TURNER B #018 API #: 30-015-05290 EDDY COUNTY, NM

PROPOSED PROCEDURE TO PLUG & ABANDON

Permanent Abandonment of Federal Wells Conditions of Approval (LPC Habitat)

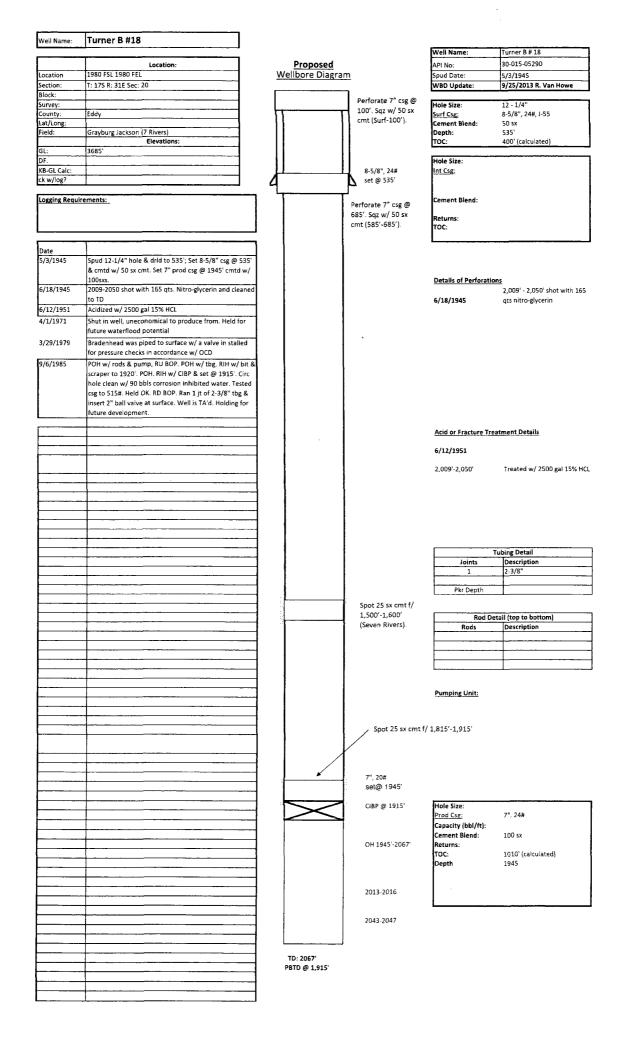
- 1. Tag 7" CIBP @ 1,915'. Spot 25 sx cmt f/ 1,815'-1,915'.
- 1. Tag / CIBP (# 1,913. Spor 20 showing)
 2. Pressure test csg. Circulate hole w/ MLF.
 3. Spot 25 sx cmt f/ 1,500'-1,600' (Seven Rivers).
 4. Perforate 7" csg @ 685". Sqz w/ 50 sx cmt (585' 685'). WOC & Tag. 585, SQZ cmt to 485.
 4. Perforate 7" csg @ 685". Sqz w/ 50 sx cmt (585' 685'). WOC & Tag. 585, SQZ cmt to 485.
